# Value Engineering Study

**Kentucky  
Transportation Cabinet**

**I-65 & KY 222 Interchange**

**Hardin County**

Alternative No.: IO-63

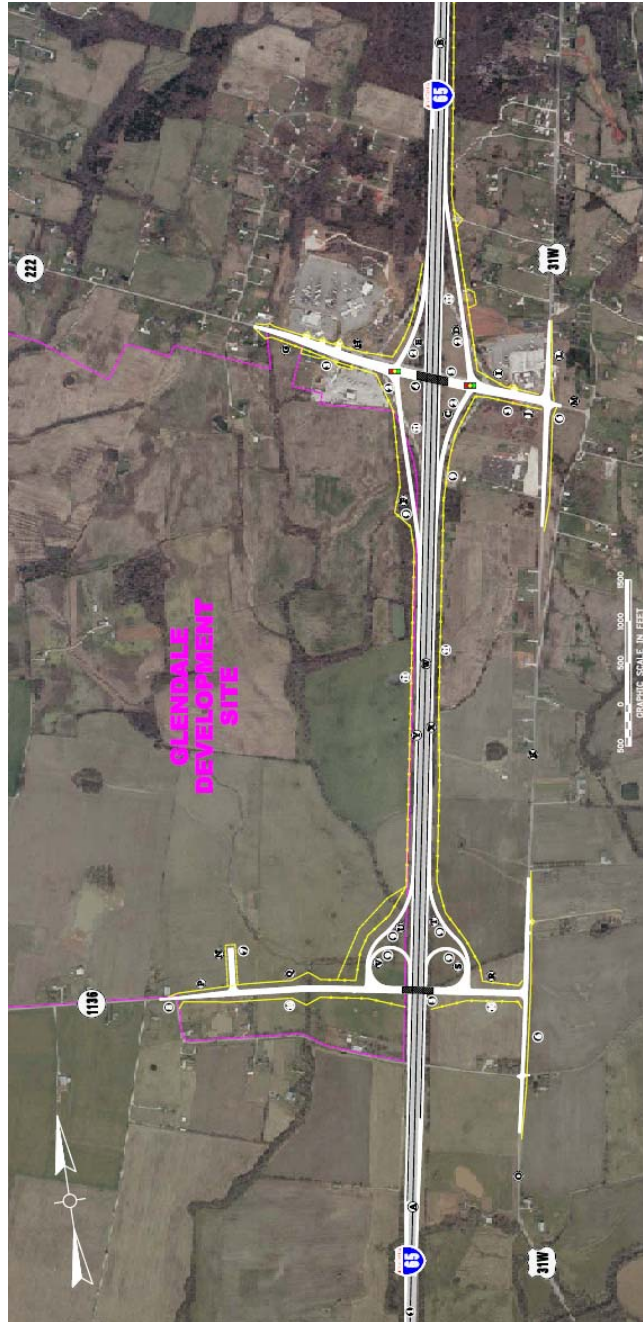
Build new KY 1136 Interchange north of Camp Nevin and collector distributor between KY 1136 /KY 222 interchange. Implement minor modifications to existing KY 222 interchange. Two-step phased implementation.

The ultimate implementation would provide a new access to KY 1136 via a new interchange, which would provide access to the potential future industrial development site owned by the Commonwealth of Kentucky.

Improvements to KY 222 include the bridge replacement with a three-lane structure. The ramp terminals would be signalized. KY 222 would remain a two-lane road but would include a ten-foot raised median between intersections. Intersection control at US 31W and for access to the industrial site could either be a traffic signal or roundabout. For traffic signals, turning lanes would need to be tapered in at both intersections on KY 222. Left turn lanes would be added on each ramp from I-65 to KY 222. Access to the properties within the influence area of the interchange are eliminated and/or reconfigured. Access to the Pilot Travel Center would be given from US 31W. The project would terminate at the industrial site intersection.

The KY 1136 interchange was developed with a folded diamond configuration north of KY 1136 to minimize impacts to the Camp Nevin historic resource that is in the area.

The alternate concept was considered in Phase 1a of the preliminary design stage but was not carried forward into Phase 1b. No documentation exists as to why this was not considered further.

**IO-54 Do not eliminate landscaping; get agreement with City and developers**

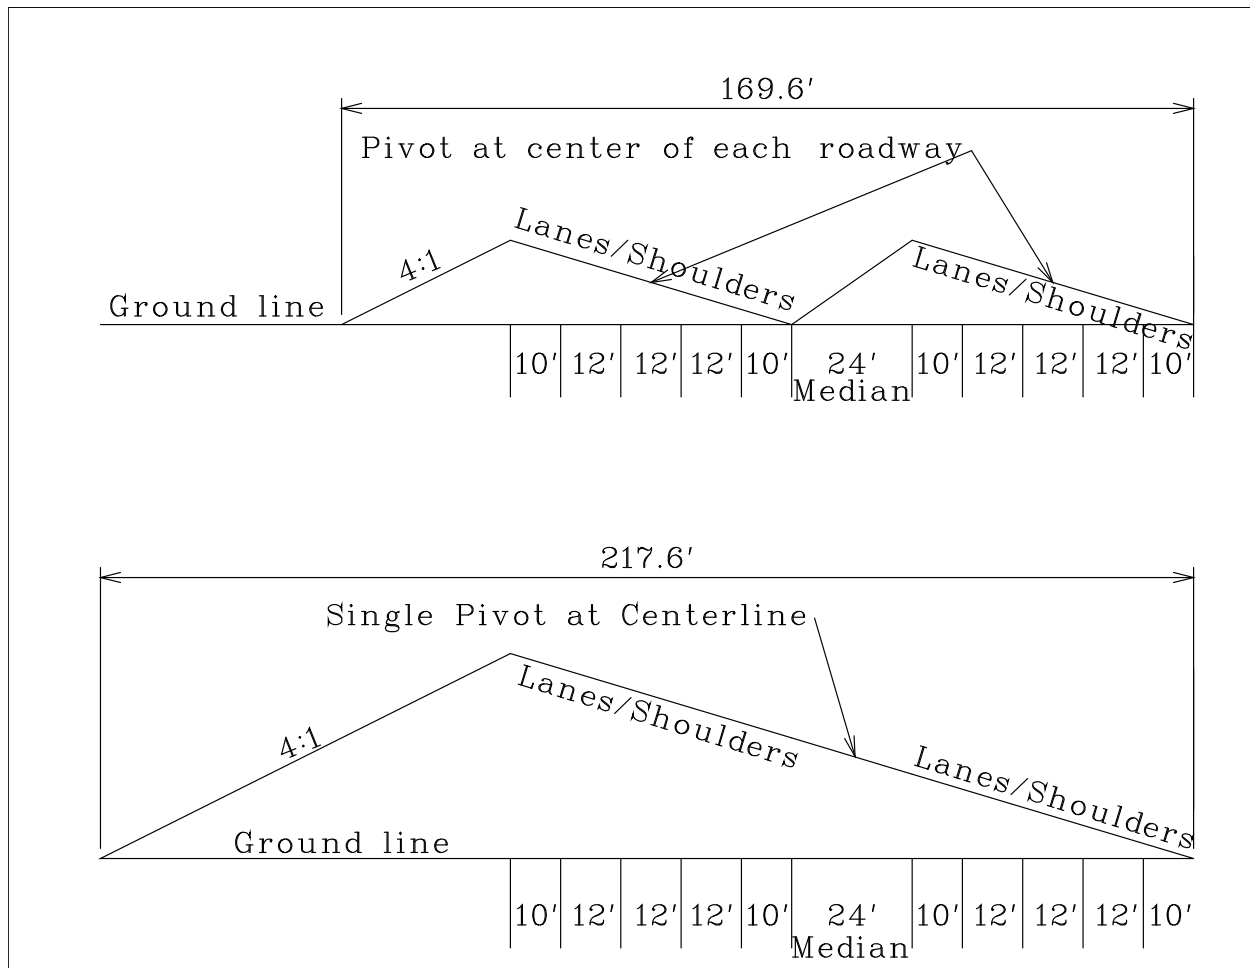
The original Preferred Alternative had included a set of aesthetic amenities including a berm, trees and a wooden four-rail fence. Considering that this is an important gateway to the historic city of Glendale, the VE Team recommends that landscaping be added back into the design. This should include the trees and fence. A shared use path may be included in the vicinity of them. Additional landscaping may be possible if an agreement can be reached with the local government to maintain it.
